Owner Change Order (OCO)

Project Name: Brookline - Driscoll School
Gilbane Job No.: J08864.000

OCO: OCO-0012

Scope Of Changes: Owner Change Order 12 Misc Changes

DRAWING NAME
 ENLARGED EXT.
 PLANS -
 CAFETERIA/TERRACE

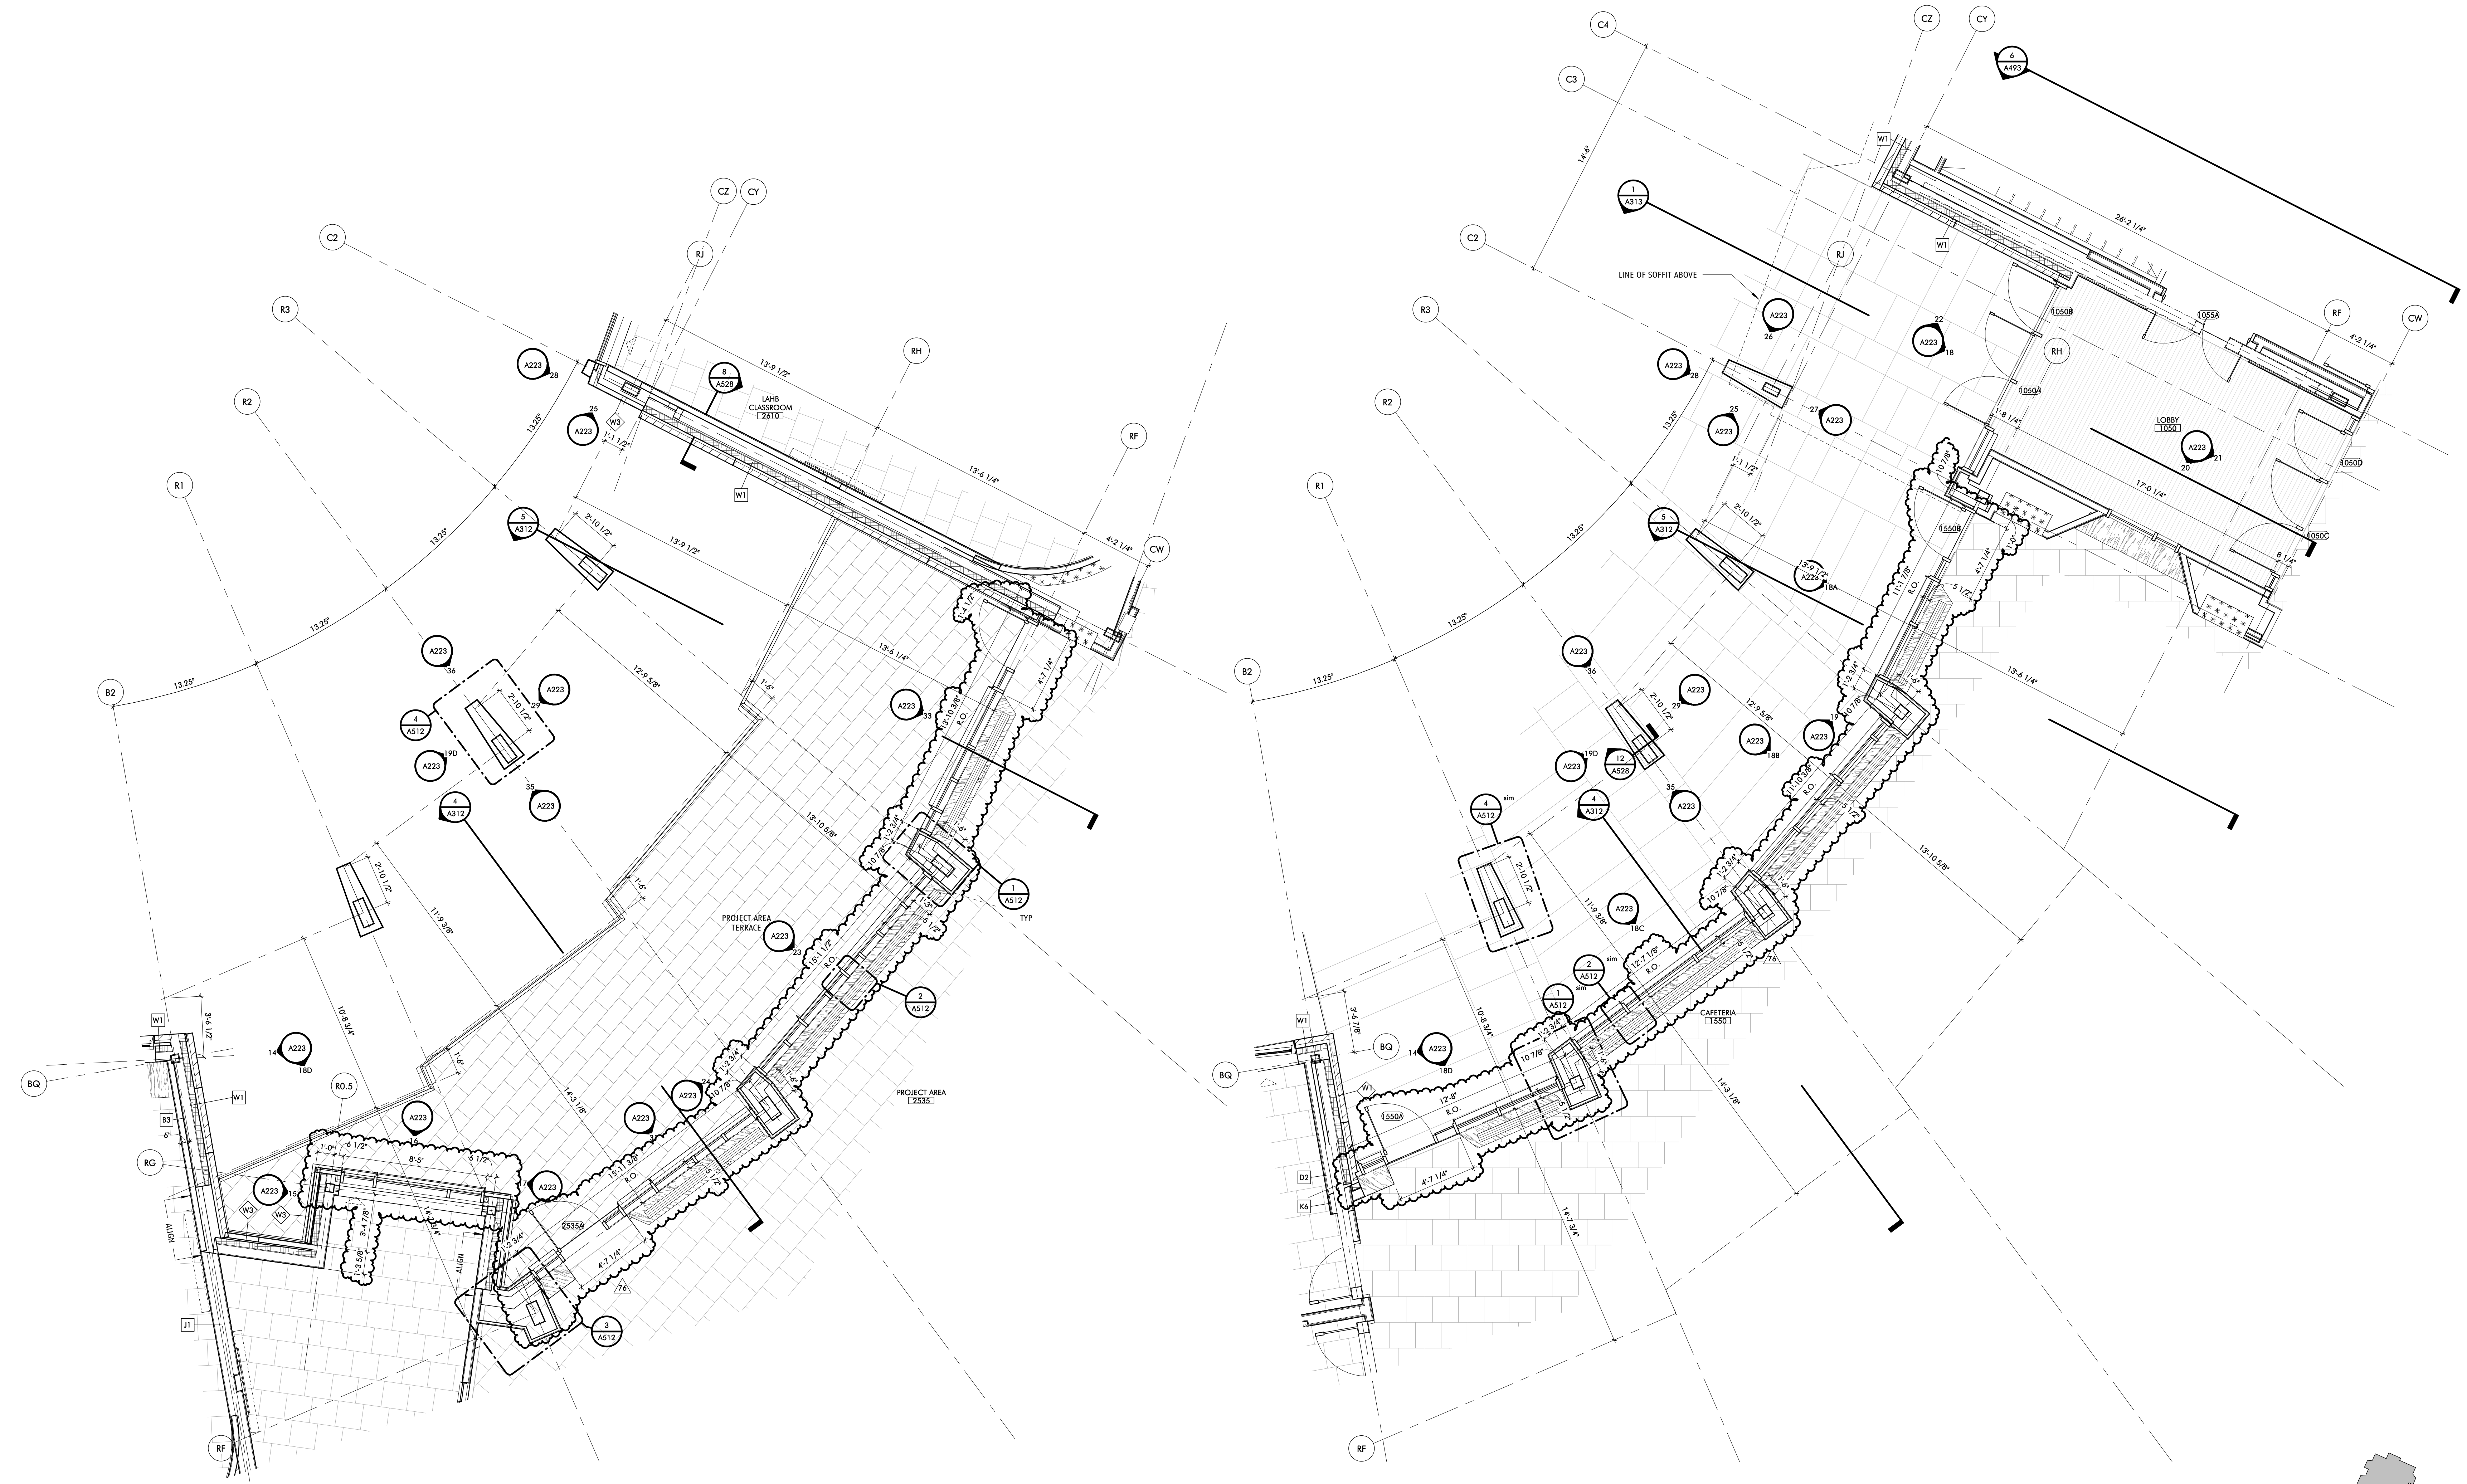
- Door 1550C at Cafeteria removed; door 1550B flipped and shifted north to allow push clearance on the interior side of the door.
- Window sill in enlarged plans updated to reflect window sill enclosure detail 3/A524. Sill at east side of door 1550A modified to allow push clearance on interior side of door.
- Column enclosures (detail 1/A512) modified per RFI 174 response to accommodate mechanical piping. (refer to A SK 053).
- Rough opening for exterior glazing updated to correspond with revised door locations and column enclosures.

DRAWING NAME
 ENLARGED EXT.
 PLANS - PROJECT
 AREA

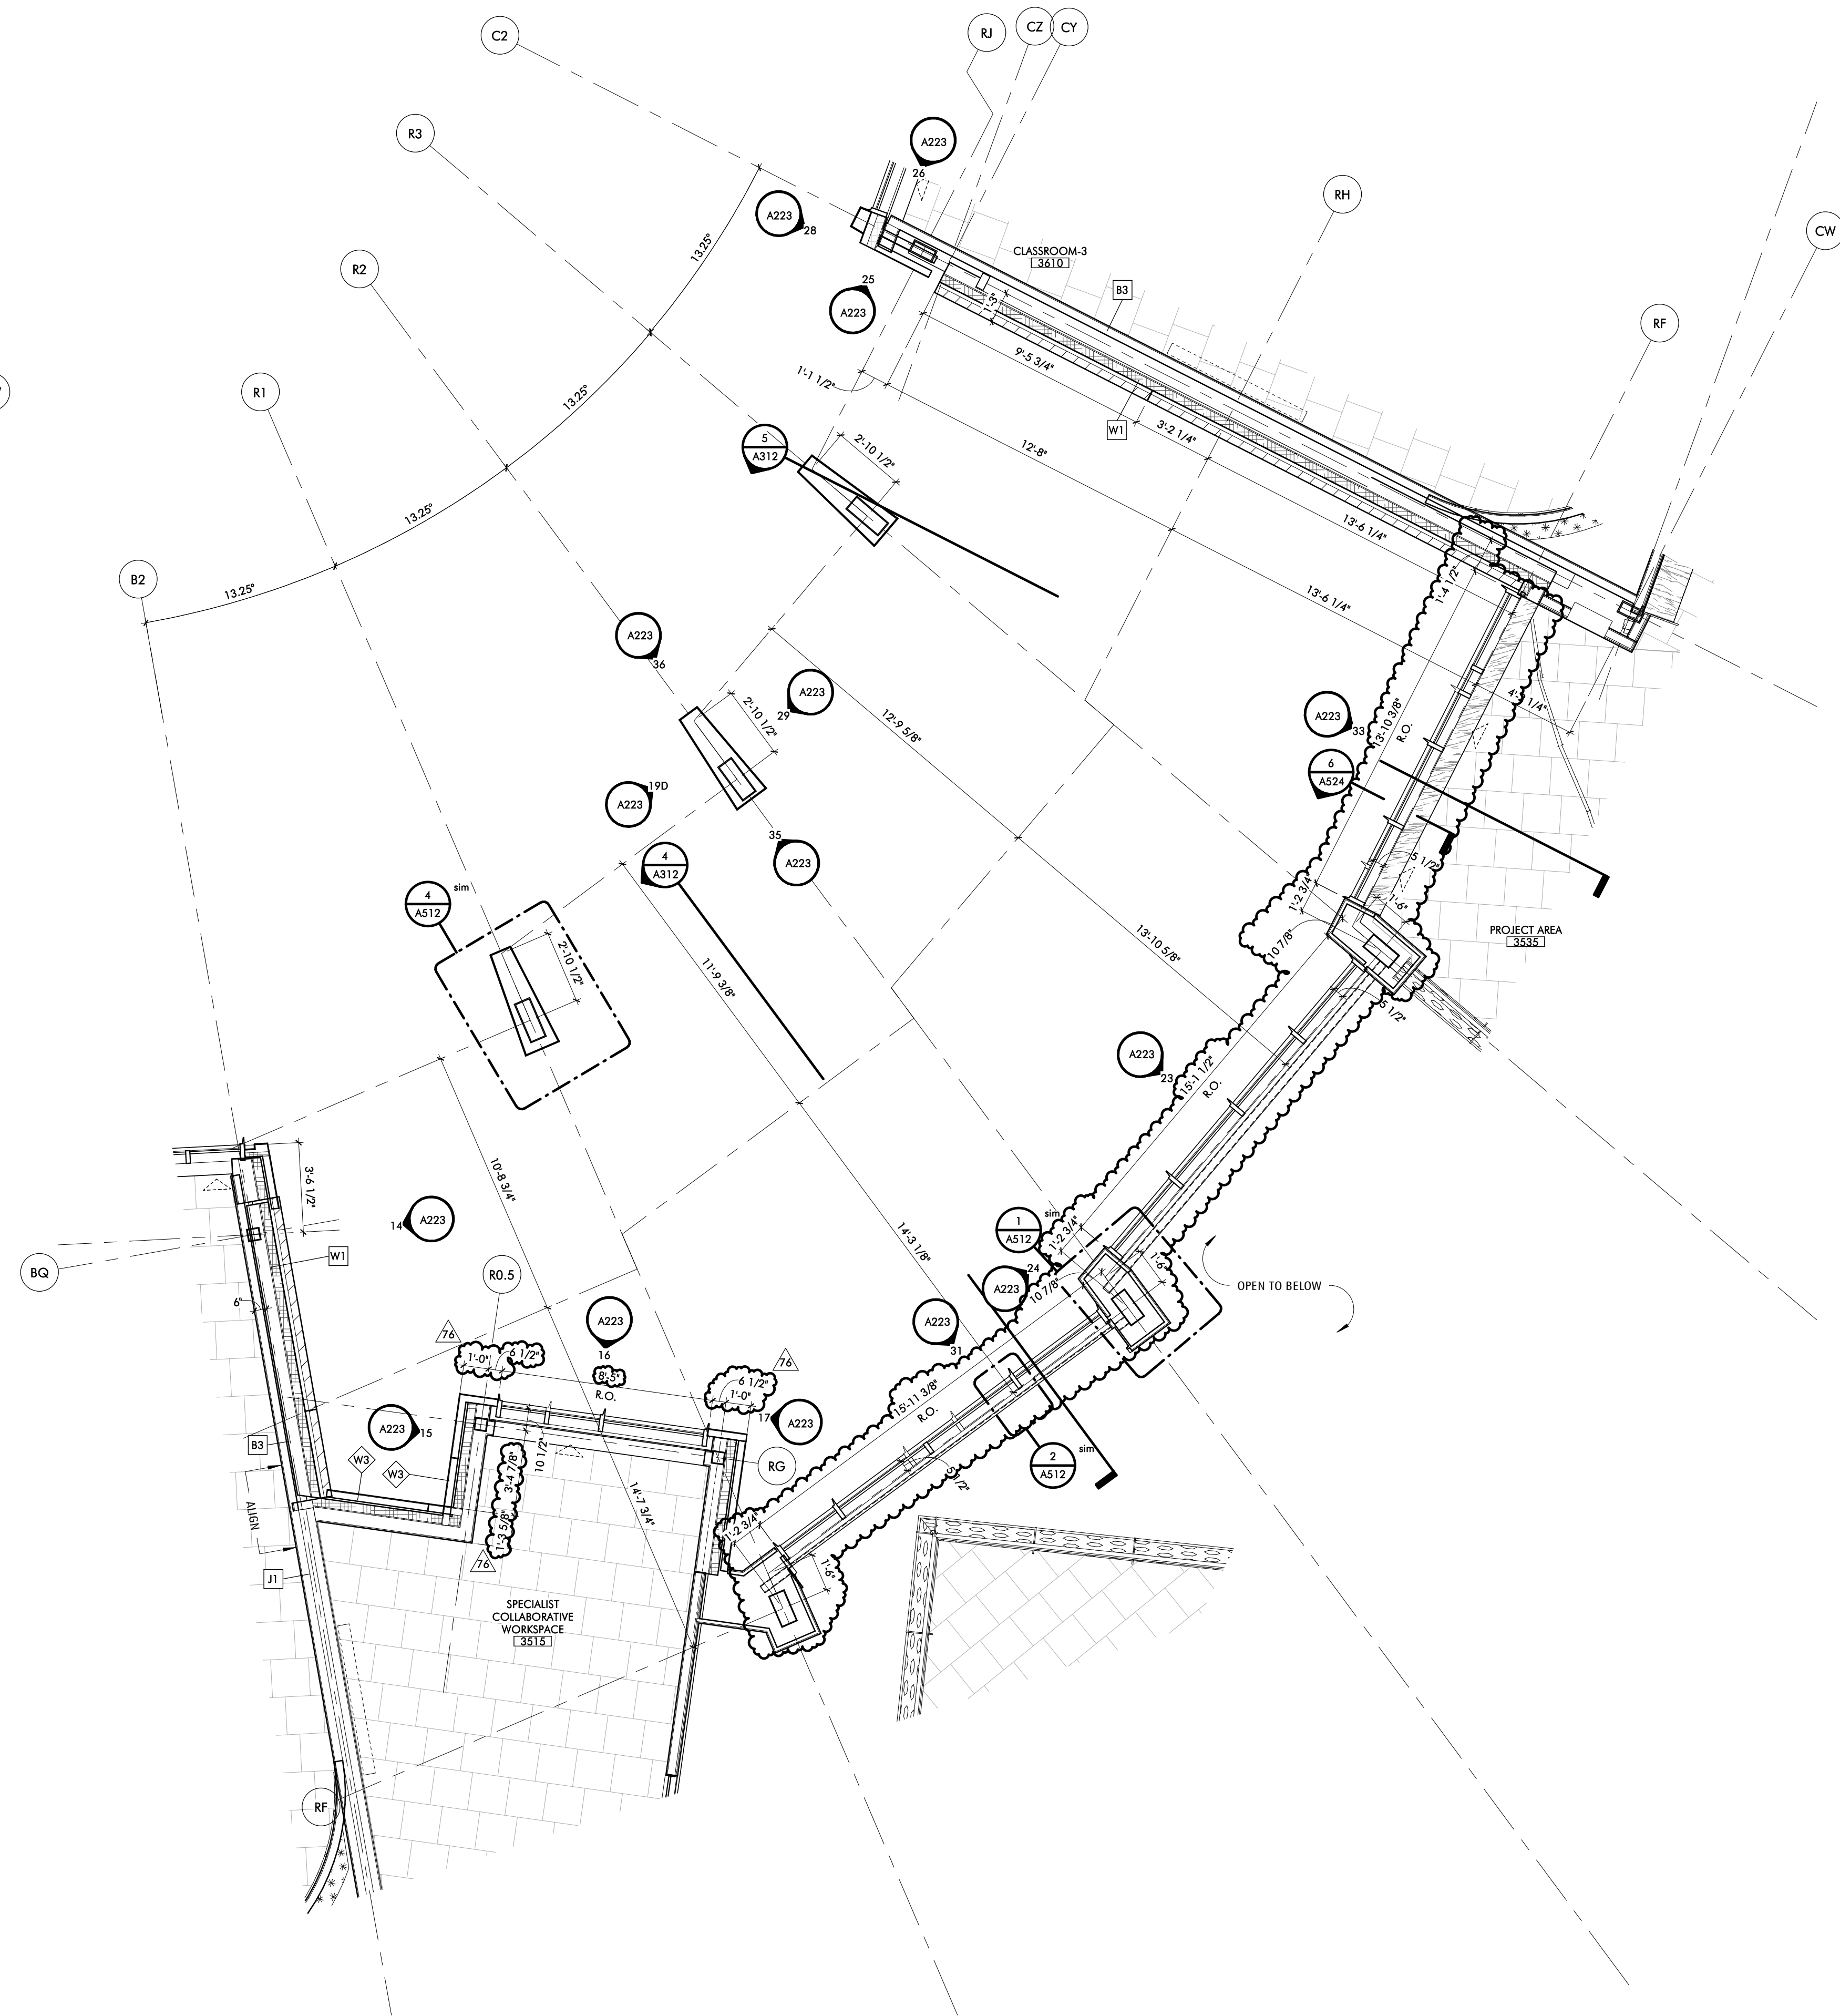
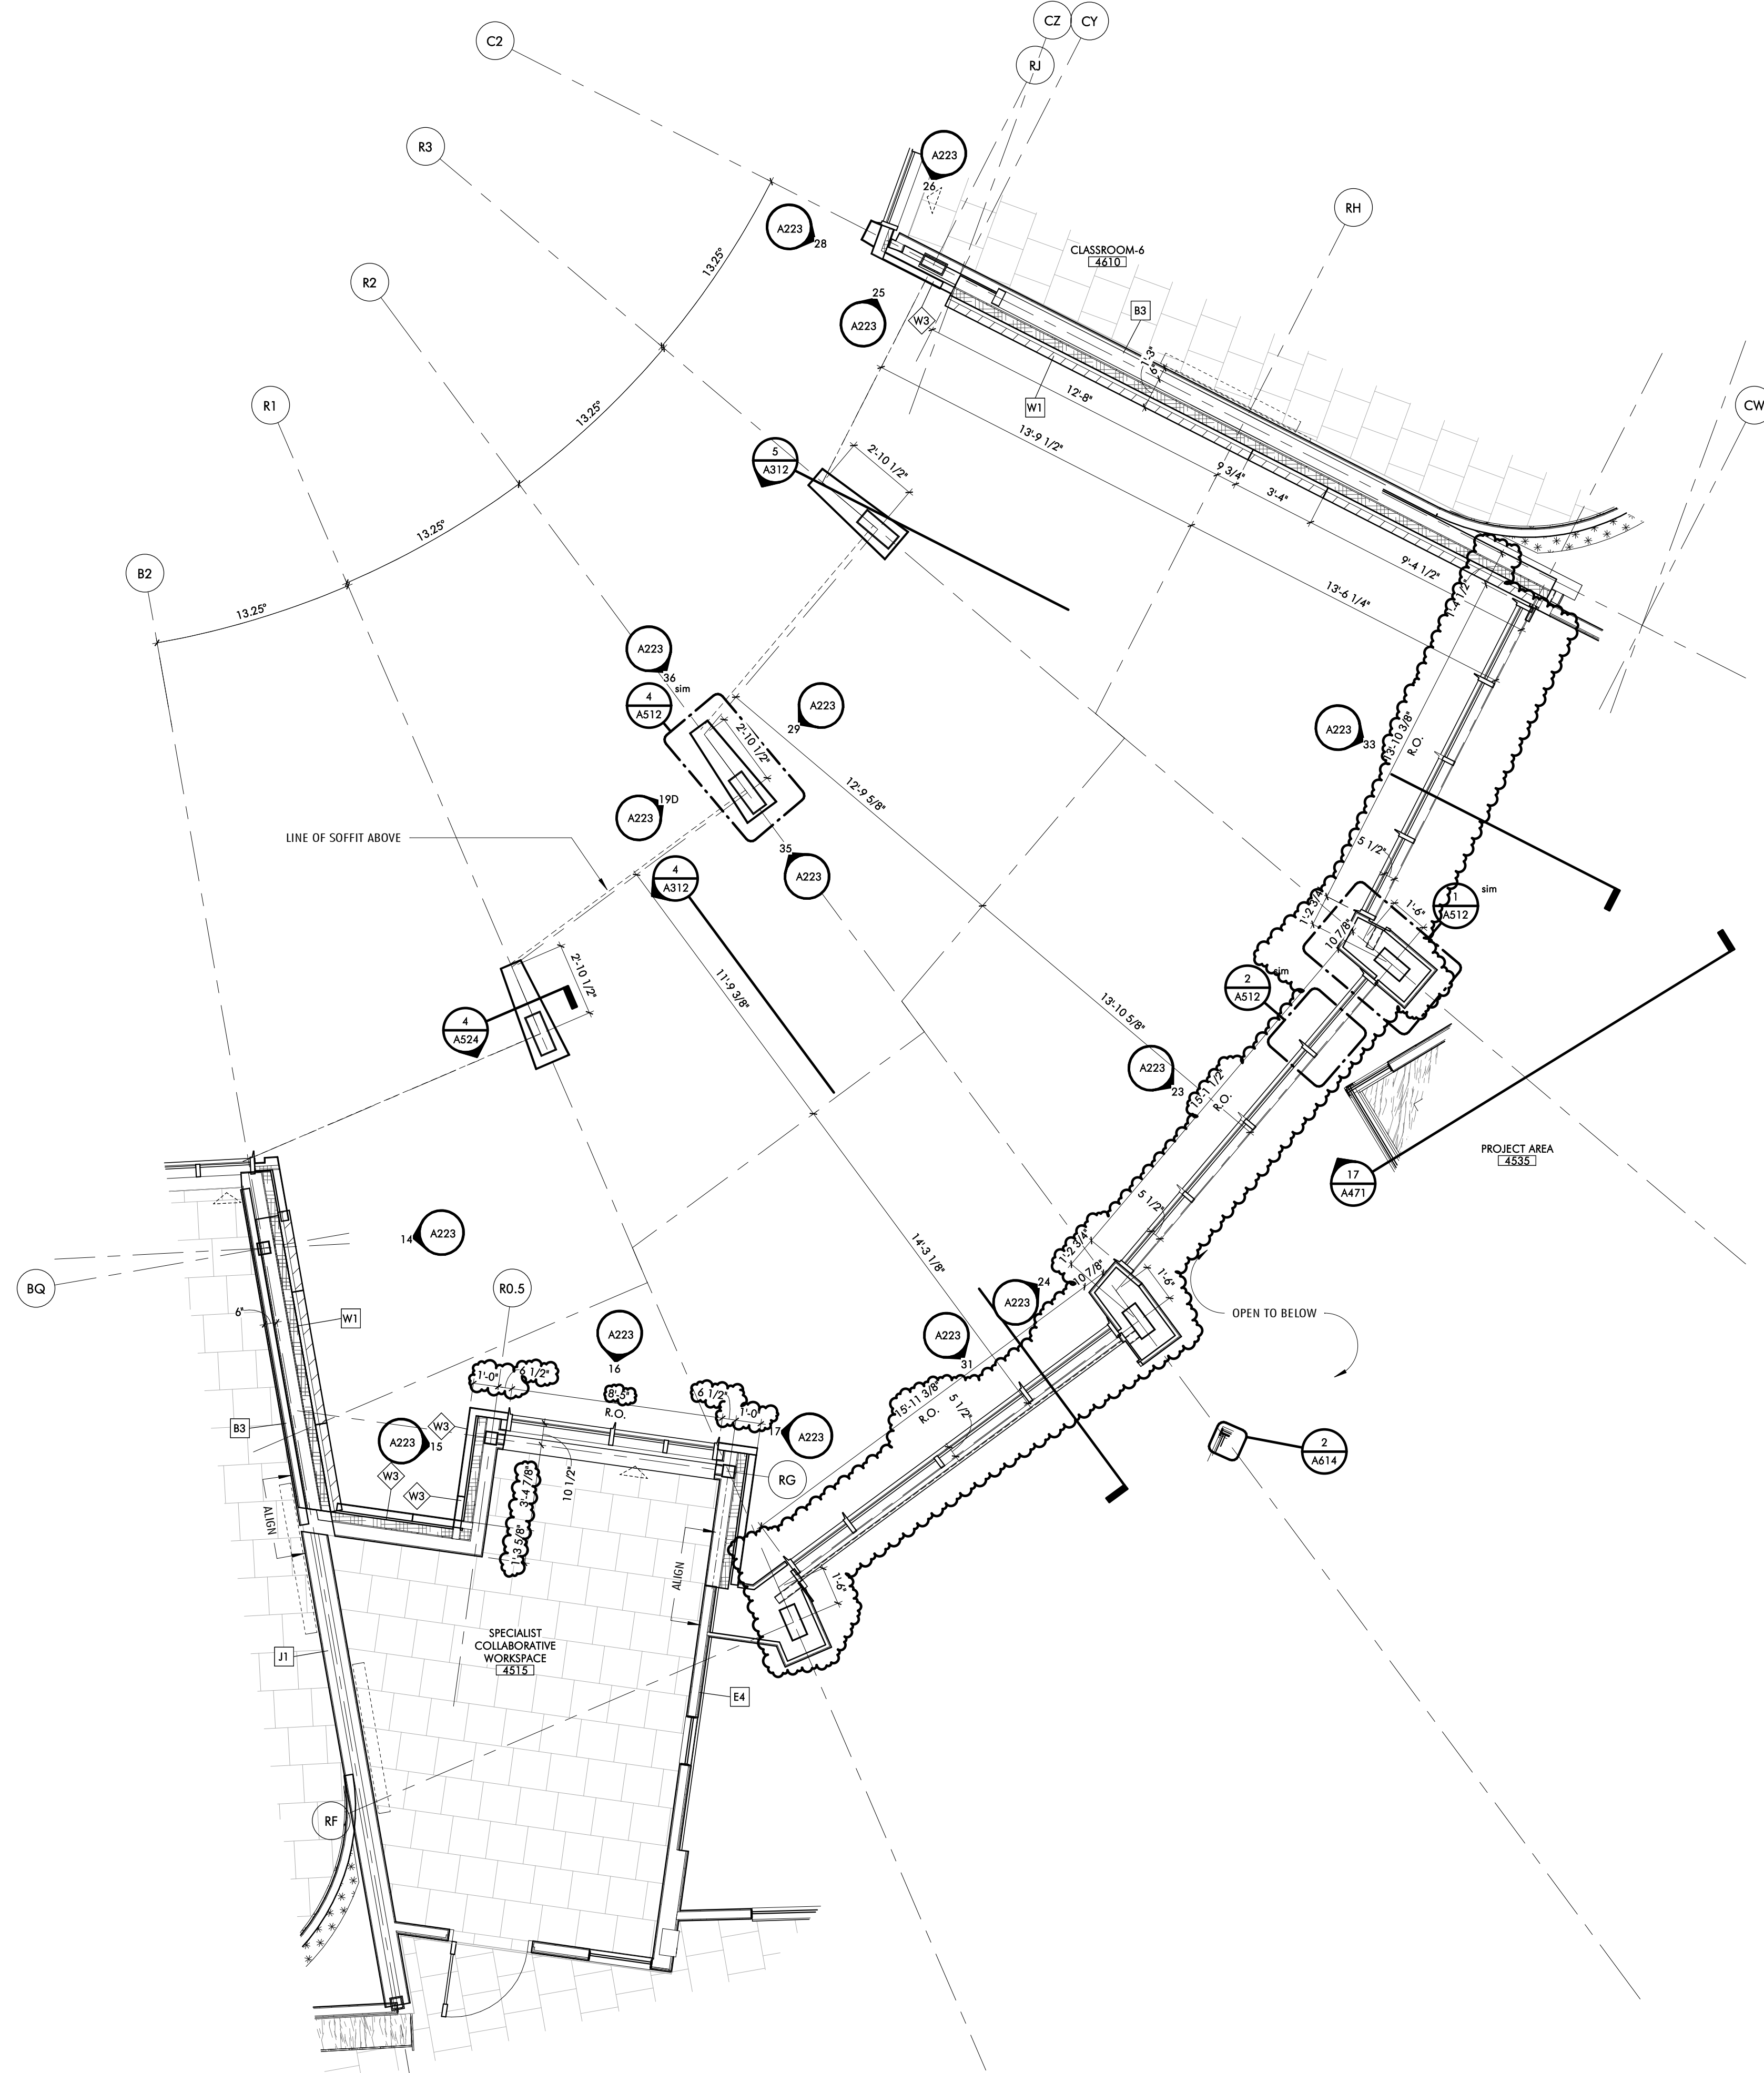
- Window sill in enlarged plans updated to reflect window sill enclosure detail 3/A524
- Column enclosures (detail 1/A512) modified per RFI 174 response to accommodate mechanical piping. Rough opening dimensions for storefront coordinated with revised door locations and column enclosures.
- Rough opening dimensions for storefront at Specialist Collaborative Workspaces reduced to allow framing around columns; outside dimension of phenolic panel modified to coordinate with EOS/ steel framing.
